LLFA DRAINAGE COMMENT / QUERY TRACKER - 31.03.2021

This tracker has been compiled to provide a detailed response to comments received by Camden Planning from the Lead Local Flood Authority in relation to the proposed development.

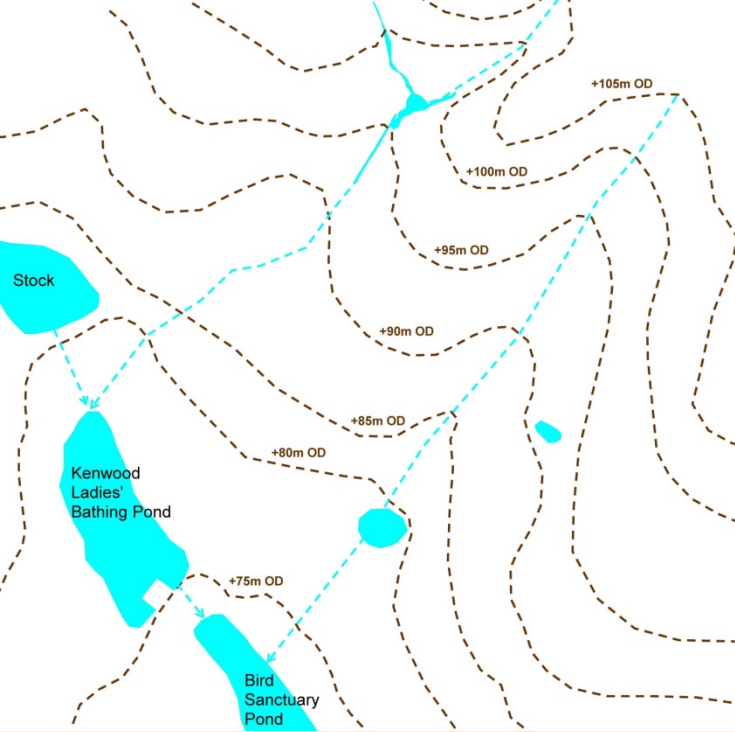
LLFA 2ND COMMENTS 04/10/2019	APPLICANT RESPONSE 24/10/2019	LLFA 3RD COMMENTS 08/11/2019	APPLICANT RESPONSE 11/12/2019
<p>Plan shows:</p> <ul style="list-style-type: none"> • 50 m³ surface water attenuation • 15 m³ swale • 3 m³ underground attenuation tank • Flow controlled rate from driveway 5 l/s <p>Issue i: the indicated storage adds to 68 m³, a shortfall of 73.5 m³.</p> <p>Issue ii: No technical details indicated for the blue-green roofs (storage volume, area/depth, void %, flow controls, discharge rates etc.)</p> <p>Issue iii: no information on freeboard requirements</p>	<p>Issue i: There is a total storage volume of approximately of 141.5m³, which is made up as follows:</p> <ul style="list-style-type: none"> • 15m³ in the swale • 50m³ in the attenuation tank • 76m³ in green and blue roof storage <p>Issue ii: The green/blue roofs will be designed by a specialist supplier/designer and it is unreasonable to request such details at this time as any specialist supplier/designer is unlikely to carry out a design without first receiving an order and deposit.</p> <p>Issue iii: The proposed house levels for the houses on the east side of the site are in excess of 1m above the level of Millfield Lane. From this it is clear there is more than ample freeboard provided.</p>	<p>Issue i: Noted. The blue-green roof storage information the Drainage Report. At least the Site Drainage Layout should be updated with the figures that make up the 76 m³. Further action requested</p> <p>Issue ii: Adequate information should be submitted at planning stage, based on outline designs generated by the drainage consultant. This is to show the LPA/LLFA how the proposed drainage measures, rates and volumes could be achieved in the scheme. Final detailed design information is not expected at this stage; it is accepted details may change, but the potential to achieve the stated aims should be demonstrated. Further action requested</p> <p>Issue iii: This request related to the SuDS freeboards as per original comment: "Provide the maximum volume each of the SuDS features can accommodate, as well as freeboard requirements in order to verify if the 141.5 m³ of attenuation required can be accommodated and indicate the discharge rate from the impermeable driveway to the combined sewer. Further action requested</p>	<p>Issue i: The roof designs will be undertaken by a specialist designer in due course.</p> <p>At this stage a conservative assumption might be made as follows:</p> <p>Assumed Approx. green/blue roof area</p> <p>Plots 1 to 3 - 80 m² each Plots 4 & 5 - 135 m² each Assumed equivalent depth water retained 150mm (3 x 80) + (2 x 135) = 510 m² 510 m² x .15m = 76.5 m³</p> <p>NB. Coyle Kennedy have provided a further assessment (attached) based upon revised areas that suggests 125m³ of blue/green roof storage to be potentially available.</p> <p>Issue ii: Coyle Kennedy have provided additional information (attached) to demonstrate how the drainage measures will be achieved.</p> <p>Issue iii: Coyle Kennedy have indicated a surplus storage capacity of some 50m³. Given that there is no potential for freeboard within the filled swale and the attenuation tank this can be accommodated within the roof designs as a freeboard of some 60mm. (see attached CK detail)</p>
